NOTICE OF DECISION

Chick-fil-A Post Decision Review

File No. PLZ-25-0126

Exhibit 2: Revised Site Plan

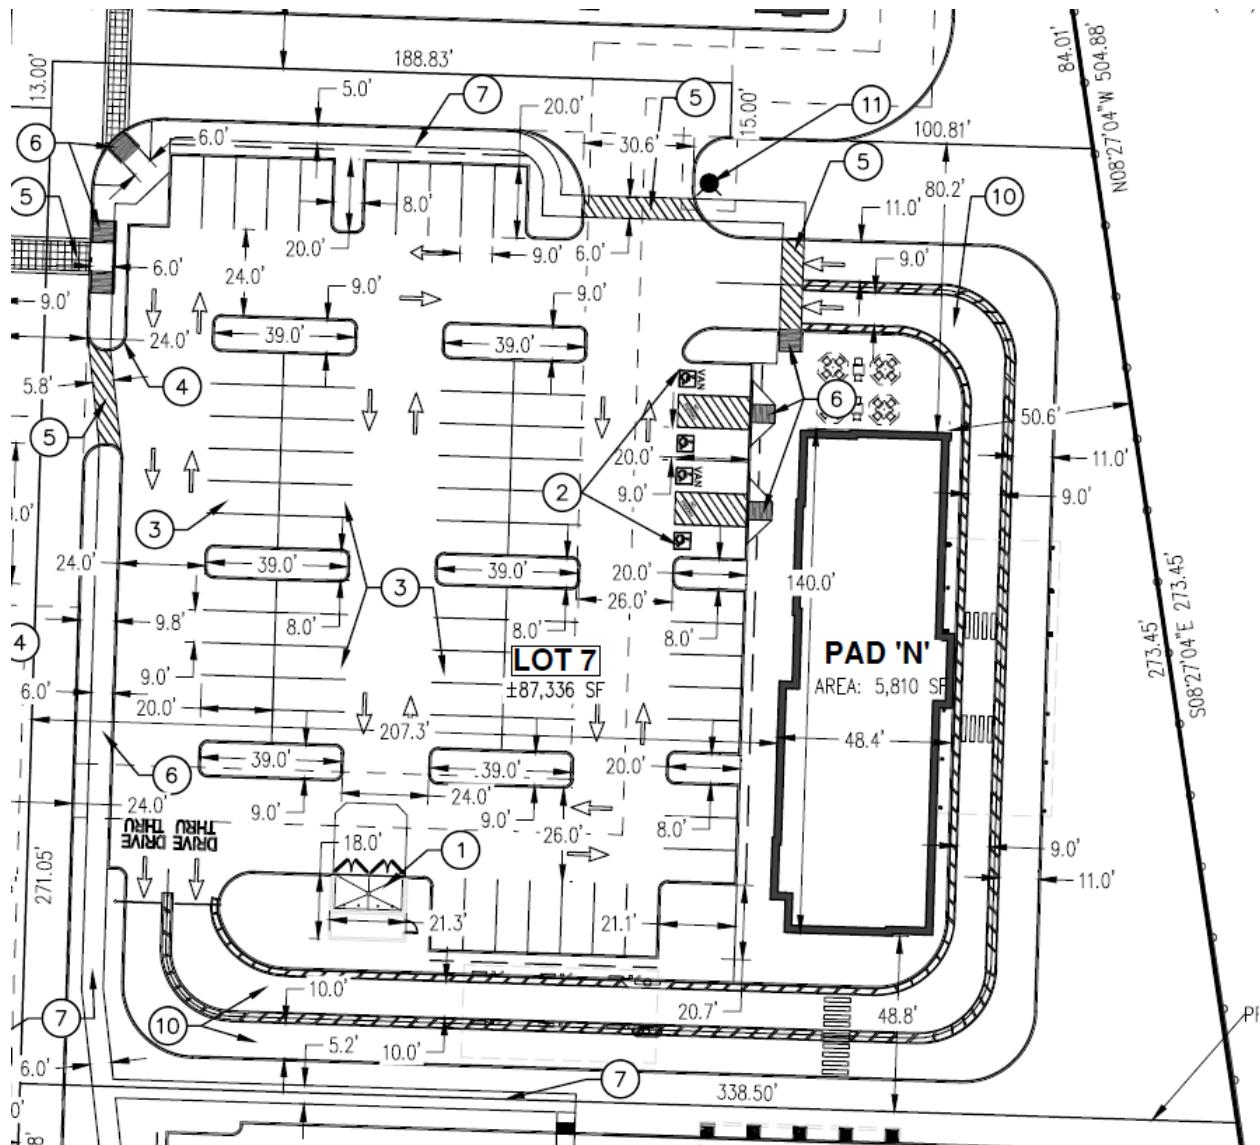
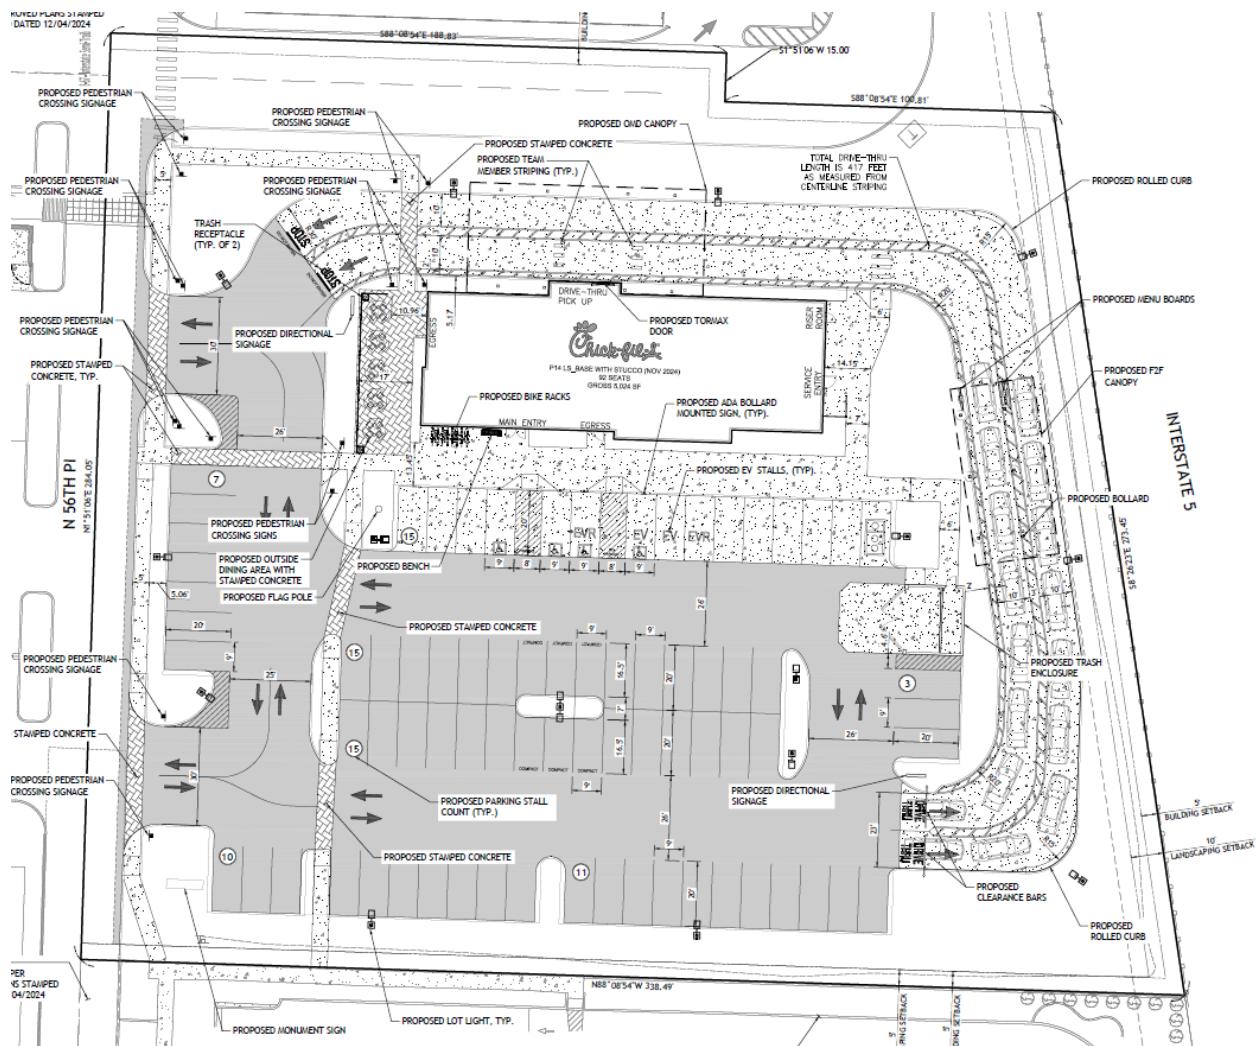
The proposed request will modify Pad N by changing the orientation of the building from the east property line to the north property line, adding stamped concrete to the common area and reducing the building size from 5,810 sf to 5,024 sf. The parking lot modification will include shifting the parking and landscape areas, adding pedestrian connectivity from the parking lot to the building entrance and adding four additional parking stalls to increase the total parking spaces from 73 to 77 spaces. Preliminary building elevations were submitted and reviewed with the application. Staff finds the project continues to comply with the standards of the CRB zone, as conditioned.

The City of Ridgefield, after review and consideration of the application materials and applicable approval criteria, **APPROVES** the URTC Pad N (Chick-fil-A) Post Decision Review subject to compliance with the following **conditions of approval**:
